Soroush Mahestan Asaloyeh Company
HDPE Project

**P.O DESCRIPTION: Centrifugal pumps**

DRAWING TITLE:
General Arrangement Drawing for 40-P-205

| DRAWING NO. | REV. | SHEET No. | SIZE |
|---|---|---|---|
| VP-40-000-MA-0011-0060 | 05 | 1 OF 1 | A3 |

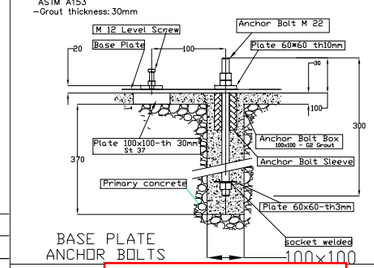
It seems unit is not correct. Please check and modify.

Repeated comment:
Unit of dynamic load location shall be specified.
